## PLANNING STAFF REPORT

I. APPLICATION DETAILS	
AGENDA ITEM:	2024-2-7
MEETING DATE:	March 19 <sup>th</sup> , 2024
	Pursuant to Section 6(1) of the New Brunswick Regulation 80-159 under the <i>Community Planning Act</i> (c.19), the advice of the Greater Miramichi Regional Service Commission – Planning Review and Adjustment Committee (PRAC) is required in order to approve the 20-metre-wide private access extension proposed from this subdivision plan.
SUBJECT:	Subdivision Plan No.2024-3 of George McCallum Subdivision at Alnwick (Tabusintac - Straight Brook Road) - Parish of Alnwick - County of Northumberland - Province of New Brunswick

## The application of Subdivision Plan No.2024-3 of George McCallum Subdivision at Alnwick (Tabusintac -Straight Brook Road) - Parish of Alnwick - County of Northumberland - Province of New Brunswick was submitted by Philippe J. Breau of Jules J. Breau and Son Ltd., representing George Kerr McCallum, the property owner. The property is located at the end of Straight Brook Road, along the South bank of the

# ATTACHMENT 2 - TENTATIVE SUBDIVISION PLAN

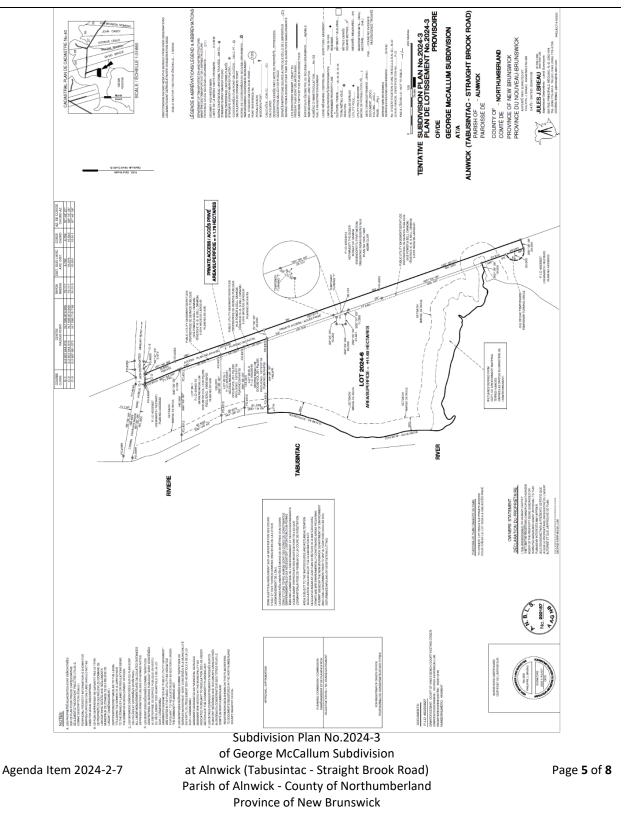
The proposed private access extension is required to connect Lot 2024-6 and the remnant to Straight Brook Road, a provincially owned public road. It measures 20 metres in width and ends with a 20-metre radius turnaround as suggested in Part B Section 1.2 of the GMRSC PRAC's *Policy for Private Accesses*. The final plan will need a note mentioning that the Department of Transportation and Infrastructure (DTI) will not upgrade or maintain this private access and that the property owner is responsible to look after these. As well, the developer shall be advised that the access should be designed to support the expected loads imposed by firefighting equipment, other emergency vehicles, and private services vehicles such as for septic tank maintenance. Therefore, the access should be surfaced with concrete, asphalt or other material designed to permit accessibility under all climatic conditions.

Lot 2024-6 meets the required frontage, depth, and area minimums as per Section 6(4) of the New Brunswick Regulation 80-159 under the *Community Planning Act* (c.19). The remnant of PID 40233827 retains an area of 23.7 hectares, more or less. Even though the proposed lot measures more than 8,050 square metres in area, a subdivision assessment report (soil test) has been provided and is satisfactory (*New Brunswick Technical Guidelines for On-site Sewage Disposal Systems*, Appendices B and B1).

Other than the Tabusintac River, the hydrographic network webmapping from the Department of Natural Resources and Energy Development (DNRED) identifies no presence of watercourses over Lot 2024-6. The wetland webmapping from the Department of Environment and Local Government (DELG) however shows presence of wetland on a portion of said lot, along the bank of the river. Therefore, any alteration taking place within 30 metres of the river or the wetland may require a permit under the Watercourse and Wetland Alteration Regulation (Reg 90-80) as per subsection 15(2) of the NB *Clean Water Act*.

As per Section 6(1) of the New Brunswick Regulation 80-159 under *Community Planning Act* (c.19), it is recommended that the Planning Review and Adjustment Committee (PRAC) of the Greater Miramichi Regional Service Commission approves *Subdivision Plan No.2024-3 of George McCallum Subdivision at Alnwick (Tabusintac - Straight Brook Road) - Parish of Alnwick - County of Northumberland - Province of New Brunswick*, provided that the following notes be inserted on the final plan:

"The private access shown on this plan is not suitable for a public street. The Department of Transportation and Infrastructure will not upgrade or maintain this private access and all maintenance services and improvements to the private access are the responsibility of the property owner"; and

"The Planning Review and Adjustment Committee (PRAC) does not carry on-site inspections of the private access shown on this plan. Construction of a private access on this parcel of land in accordance with all relevant regulations, if any, is the strict and sole responsibility of the property owner or developer. The PRAC expressly makes neither representations nor warranties of any nature whatsoever that the condition and construction of the access is suitable for safe movement of vehicle traffic. The PRAC only approves the location of the access shown on this plan and not its condition and makes no representation nor warranties whatsoever with respect to the condition of the access."
